SERVICE BULLETIN 176E

March 3, 2003

SUBJECT: Necessary Actions Following Object Strike of Stationary Propeller, Blade Strike of Rotating Propeller, Bird Strike, or Sudden Engine Stoppage

MODELS AFFECTED: All McCauley Propellers

Figure 1

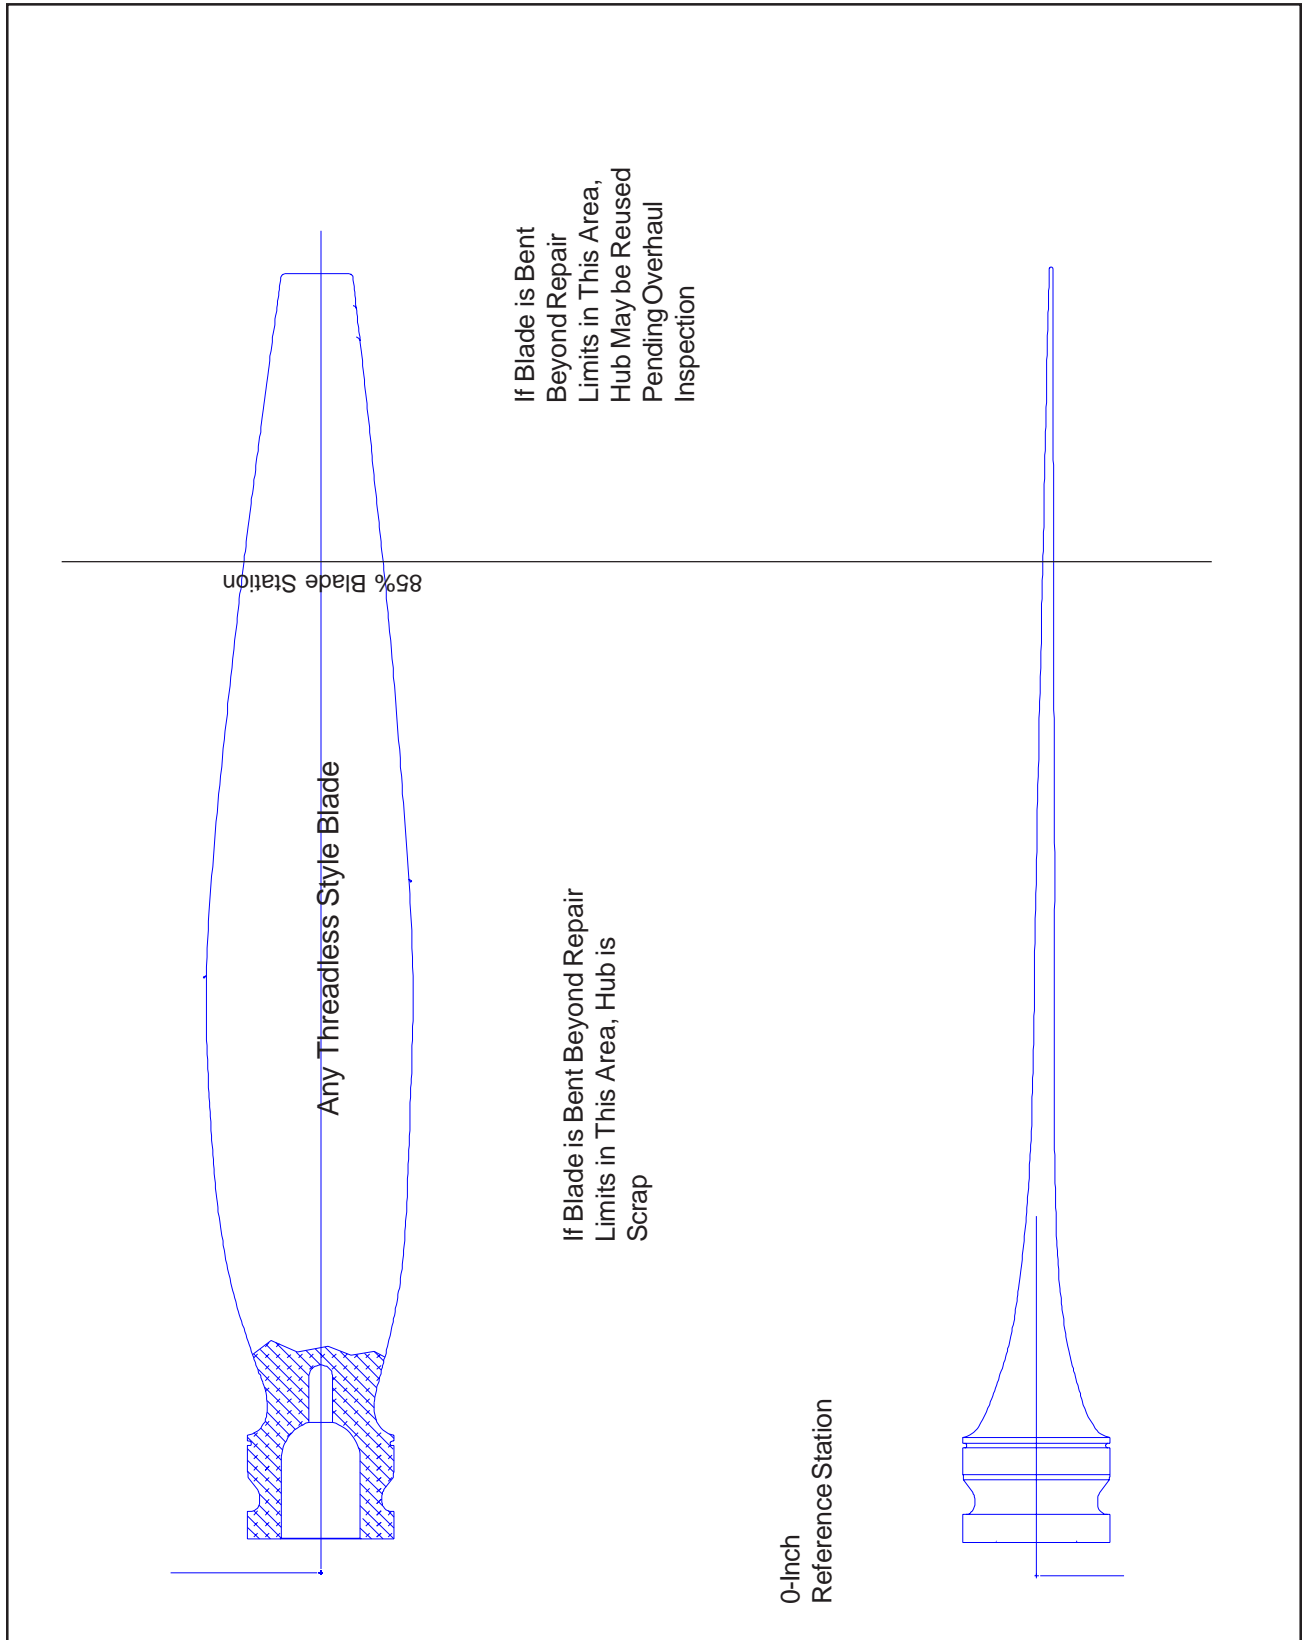
A hub must be declared unairworthy and scrapped if any blade in the propeller assembly is bent beyond repair limits within the first 85% of total blade station radius (Refer to Figure 1 and 2). A hub may be returned to service, pending normal overhaul inspection, if any blade in the propeller assembly is bent beyond repair limits outboard of the 85% blade station radius.
